Subject: V. C. Summer Nuclear Station Units 2 and 3
Docket Numbers 52-027 and 52-028
Combined License Application – Response to NRC
Environmental Report (ER) Requests for Additional Information
(RAI): BenCost-1 and GW-2 Supplemental Response

**VCSNS UNITS 2 and 3
Environmental Report Review
Response to NRC Requests for Additional Information**

NRC RAI Number: GW-2 **Revision:** 1

Figure 1. Control volume and potentiometric level contours in the saprolite/shallow bedrock for March 2007.

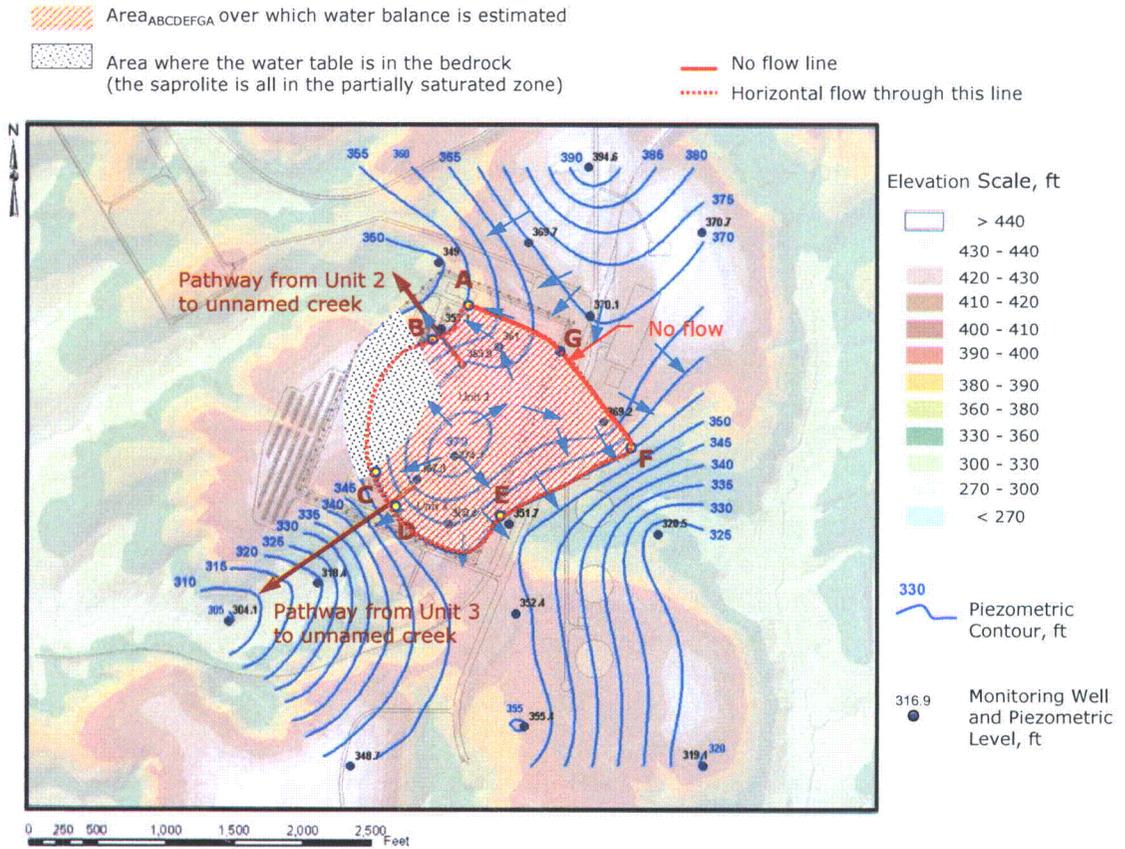
Describe the selection and uncertainties in the conservative hydraulic conductivity values used in the groundwater pathline analysis for the saprolite/shallow bedrock zone and deep bedrock zone.

To demonstrate the validity of the choice of 1.7 ft/day as the representative average conductivity for the site it is necessary to consider water balance for a control volume below the top of the ridge at the site of Units 2 and 3, specifically within area ABCDEFGA in Figure 1, and extending to the upper 10 ft of the deep bedrock. The contours shown in this Figure are reproduced from the VCSNS FSAR Figure 2.4-240. It is assumed that there is no flow to any deeper zones in the bedrock. Figure 2 shows the control volume and the potentiometric level contours in the deep bedrock. The contours shown in this Figure are reproduced from the VCSNS FSAR Figure 2.4-244. The potentiometric levels shown in both Figure 1 and Figure 2 are based on data collected in March 2007 (see VCSNS FSAR Table 2.4-221). The water balance analysis accounts for two materials, the saprolite and the shallow part of the bedrock (partially weathered rock) treated as one unit and the top 10 ft of the deep bedrock treated as the second unit. As can be seen in Figures 1 and 2, the flow direction across the boundary of the control volume in each of the two materials is not exactly the same.

Q_S is the total flow through the saprolite/shallow bedrock out of the control volume passing through segments AB and CDEF in Figure 1. (It is noted that there is no flow through the segment FGA and in the segment BC the water table is in the deep bedrock zone, i.e. the saprolite and shallow bedrock are in the unsaturated zone.)

In Equation (6), the parameters i_S , i_B , L_S , L_B and A can be estimated directly from Figure 1 and Figure 2. The average saturated thickness of the saprolite/shallow bedrock D_S can also be estimated from the available data. The average thickness of the deep bedrock through which there is groundwater flow, D_B , is assumed to be 10 ft. The mean annual recharge rate can be estimated as a fraction of the mean annual precipitation, which is approximately 45 inches (see VCSNS FSAR Section 2.4-1). The average annual recharge over the continental U.S. is about 10% of the mean annual precipitation (Singh, 1992).

The hydraulic gradient in the saprolite/shallow bedrock (0.03) was calculated as the average along the part of the boundary of the control volume through which there is flow. The hydraulic gradient in the bedrock (0.04) was calculated as the average of two values, 0.06 to the west of Units 2 and 3, which was obtained from the contours shown in Figure 2, and 0.02 to the east of Units 2 and 3. The latter was obtained by dividing the potentiometric level difference between Units 2 and 3 and Mayo Creek by the corresponding distance.
